3.10.3 Level 02

4.0 SCALE & MASSING

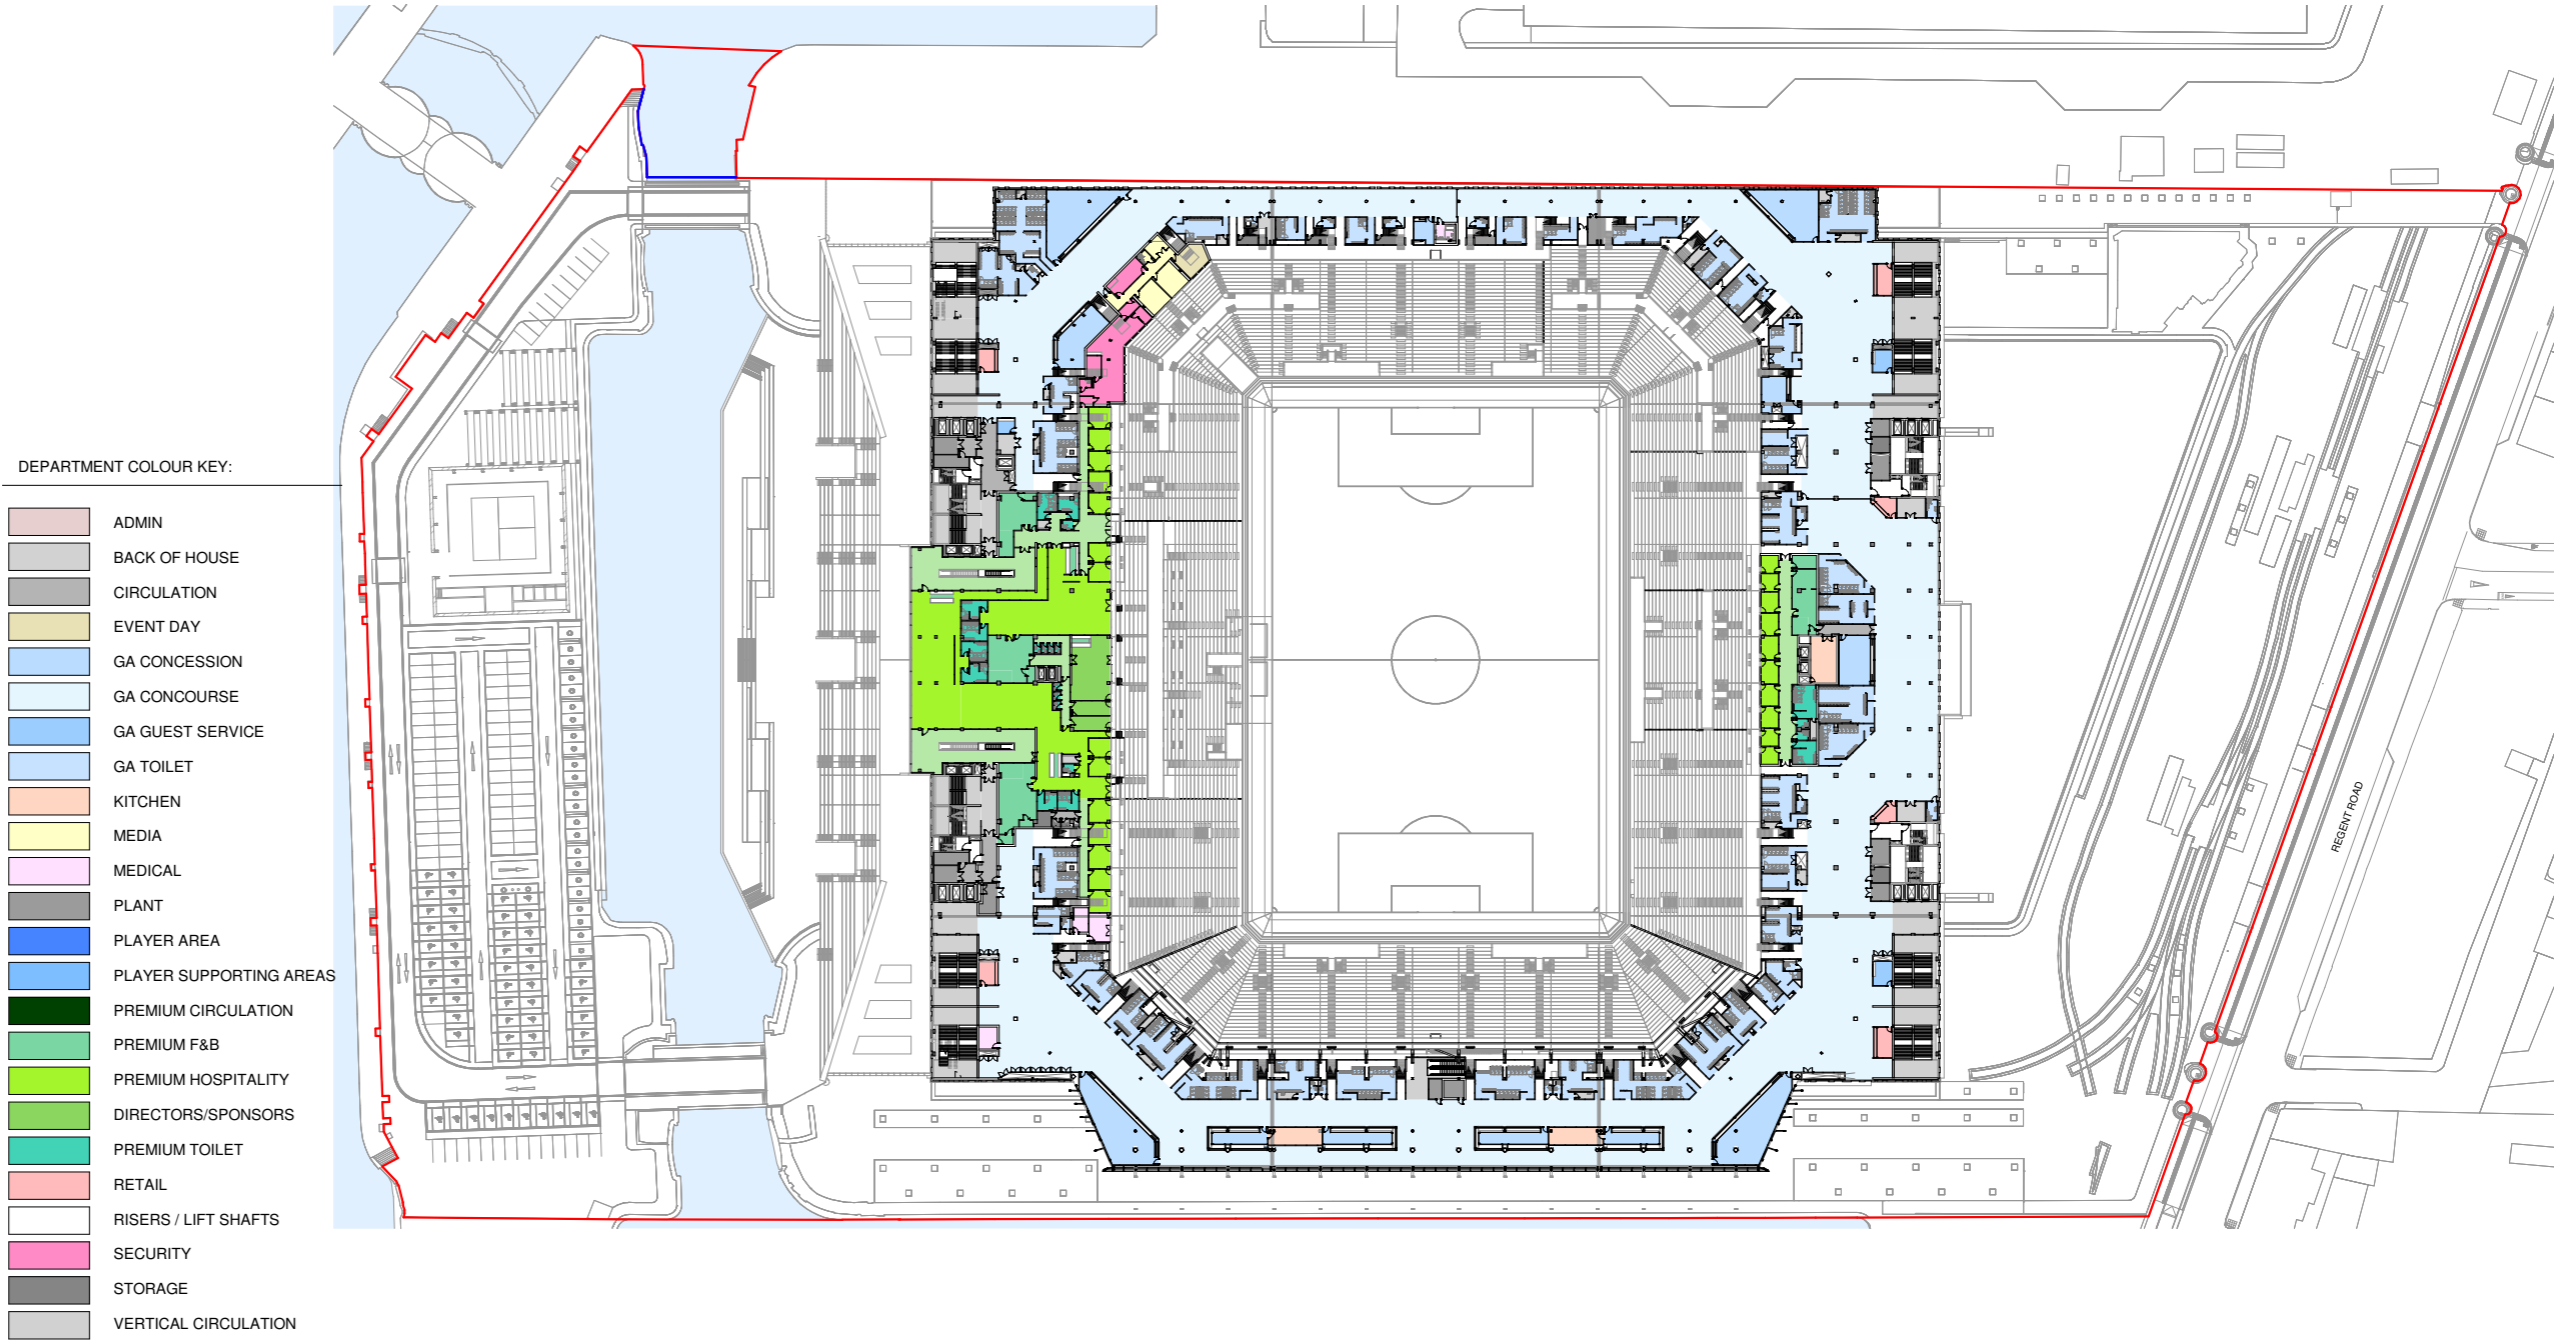
- General admission concourse redesigned to maximise available facilities and rationalise concourse area
 - Corner stairs area reconfigured for improved circulation and efficient use of space
- Additional area at corner stairs has been utilised for merchandise, gaming pods, and an extra First Aid room
 - South stand home bar has been developed as 4 areas, for more efficient operation, and to open up a central view through the southern glazed wall to the city centre
 - New south escalator access to south stand and home bar
- West hospitality lounges redesigned as per the Club's revised brief.
 - River views maximised from hospitality circulation areas and lounge
 - East hospitality boxes redesigned to maximise facilities

Level 02 layout plan

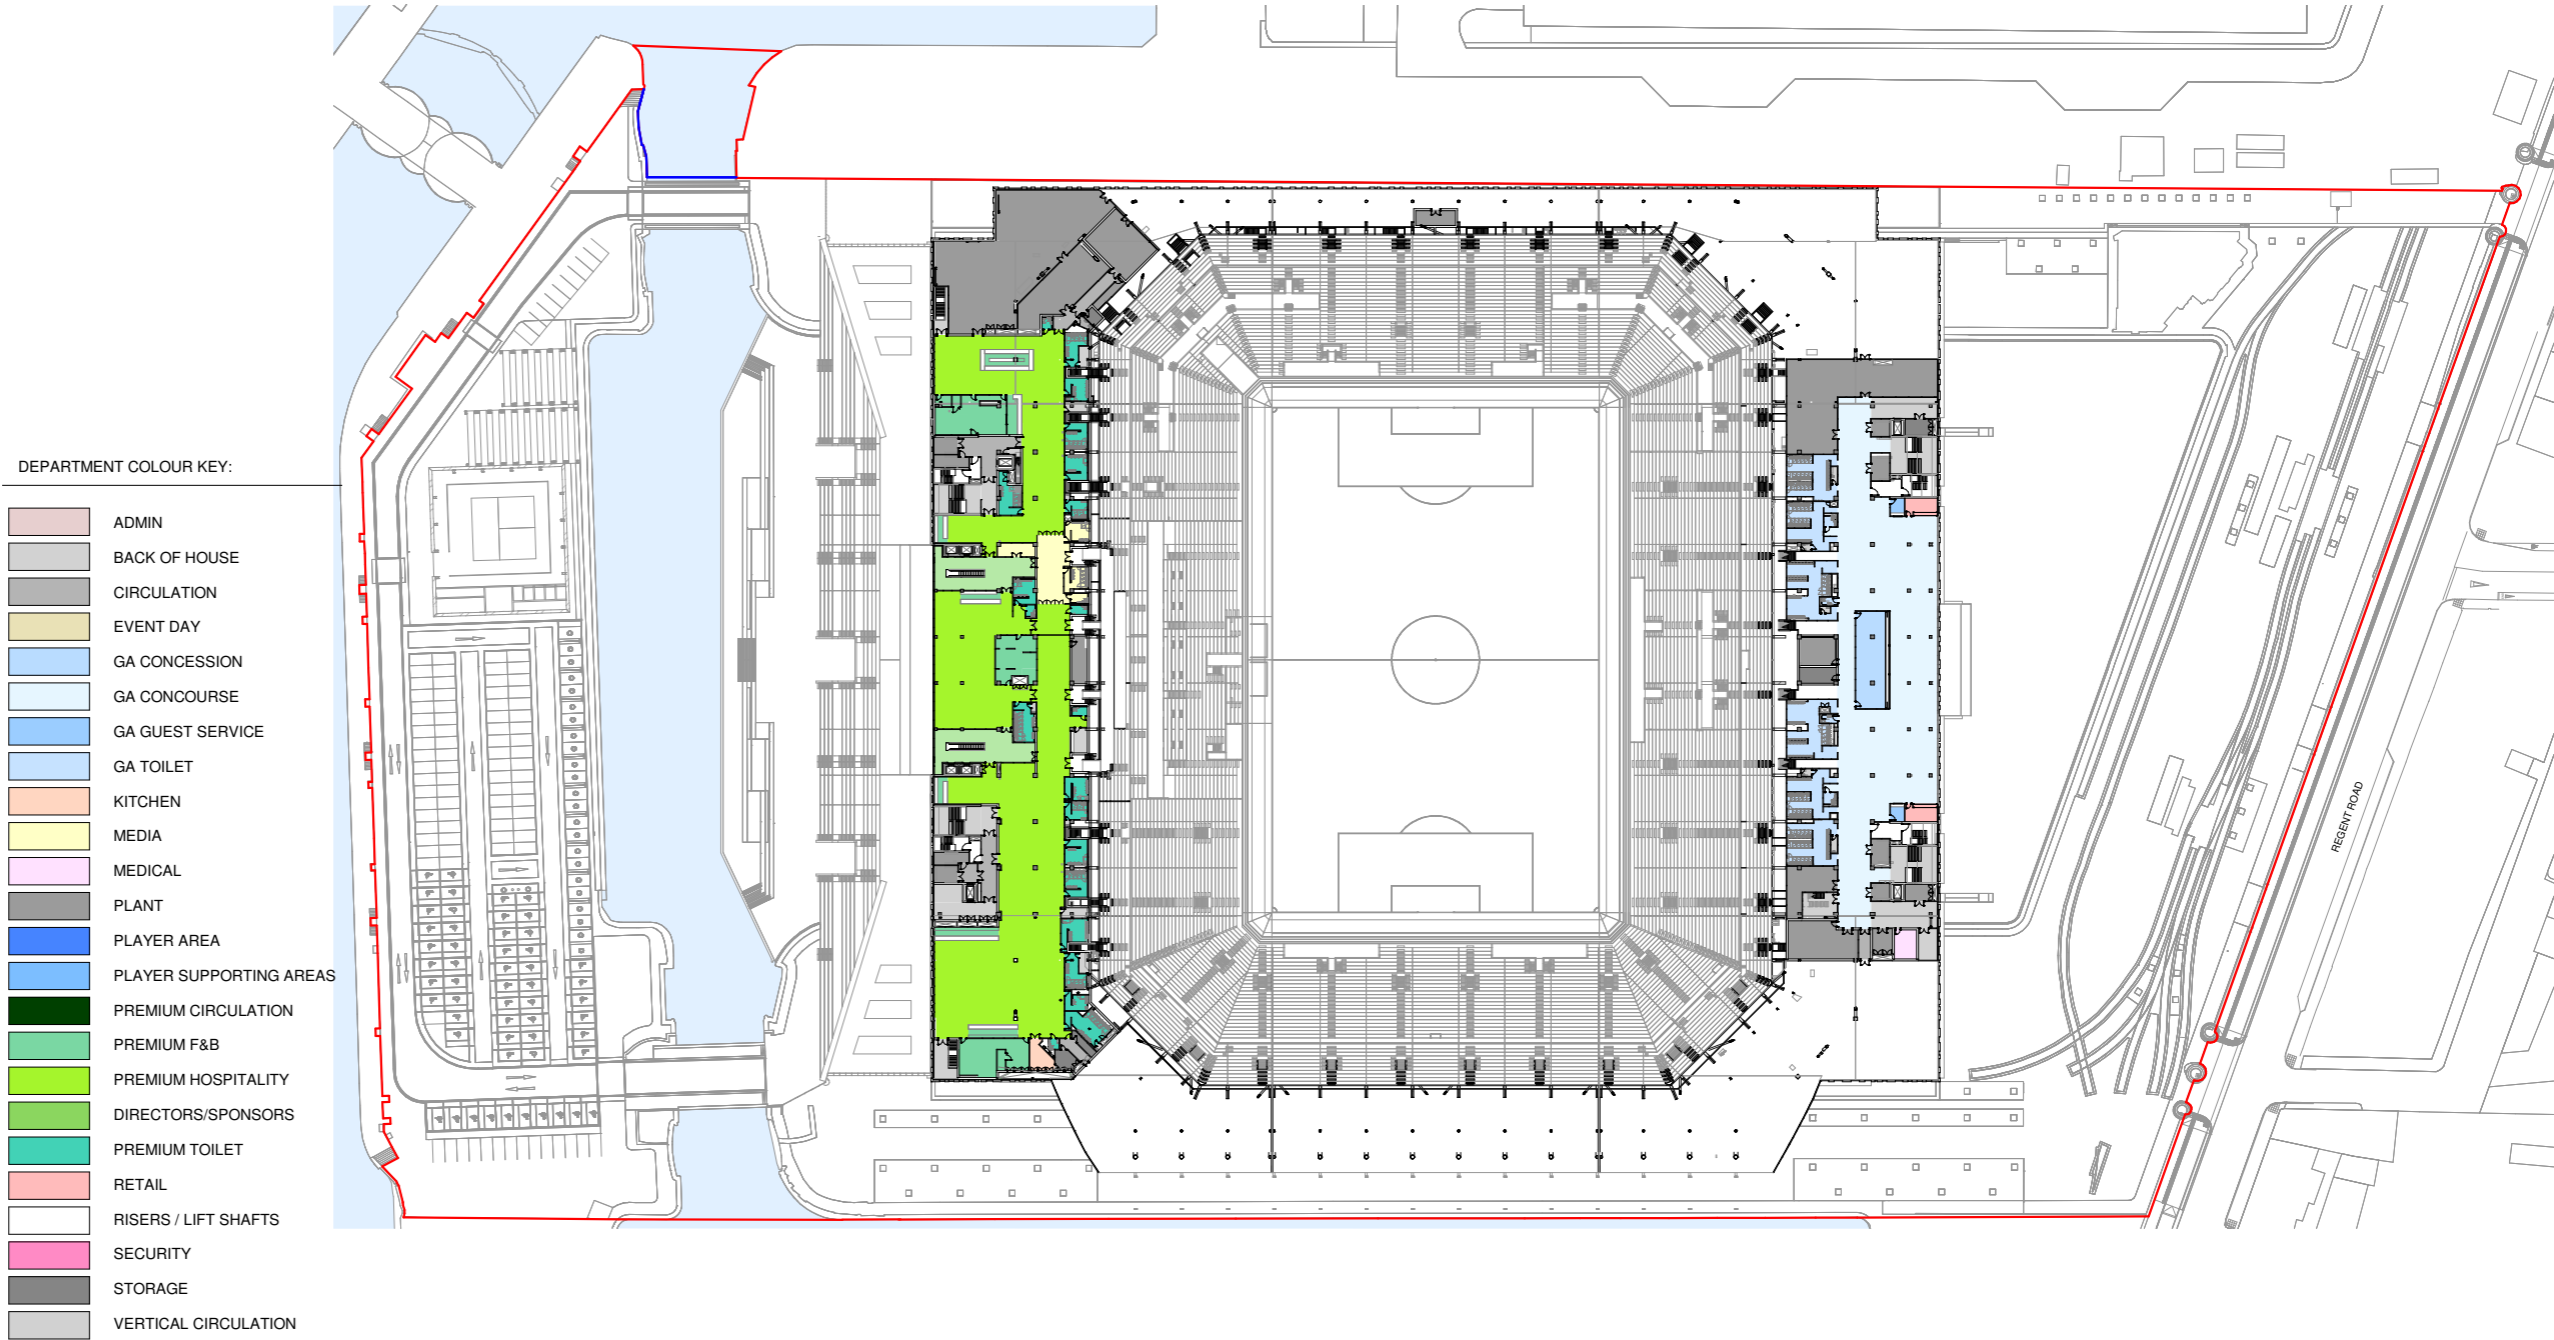
- East general admission concourse redesigned to maximise available facilities and rationalise concourse area
- Corner stairs area reconfigured for improved circulation and efficient use of space
- West hospitality lounges redesigned as per the Club's revised brief
- River views maximised from hospitality circulation areas and lounge with glazed facade for central river-view dining
- East and west areas have been lengthened to house relocated plant rooms (previously in the MSCP)
- The north and south areas remain as flat roof areas

Level 04 layout plan

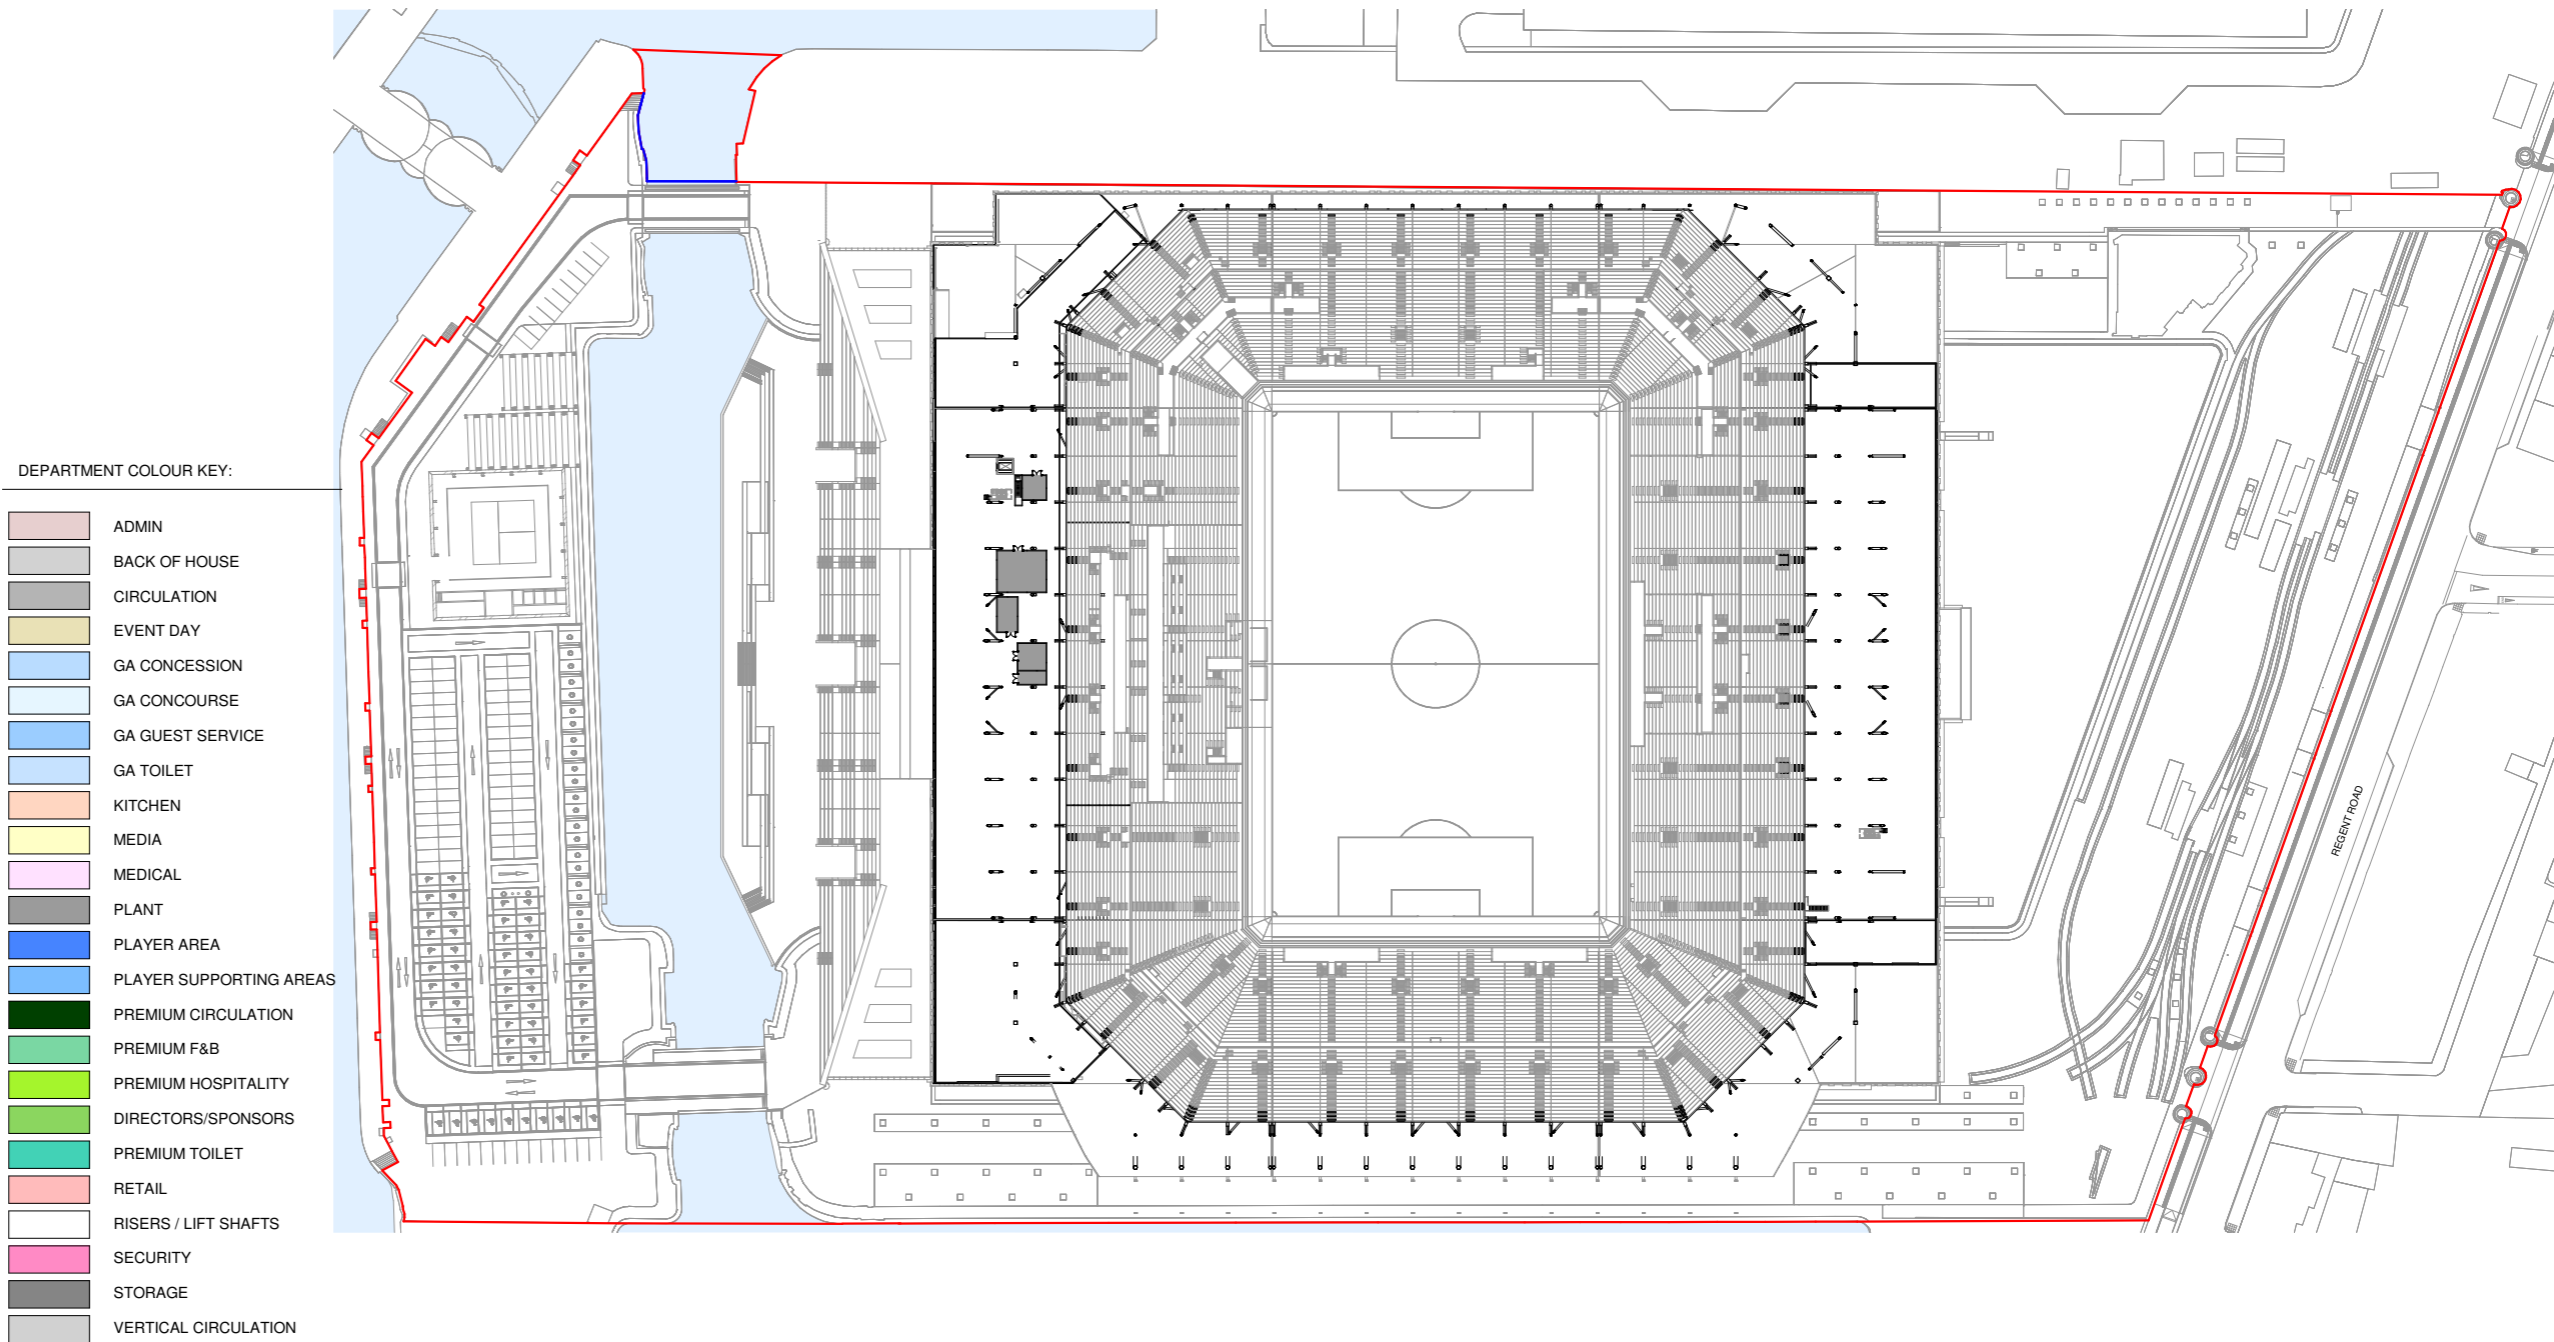
- A small number of plant rooms sit in the west stand hidden behind the barrel roof cladding
- The rest of the area is flat roofs for the levels below
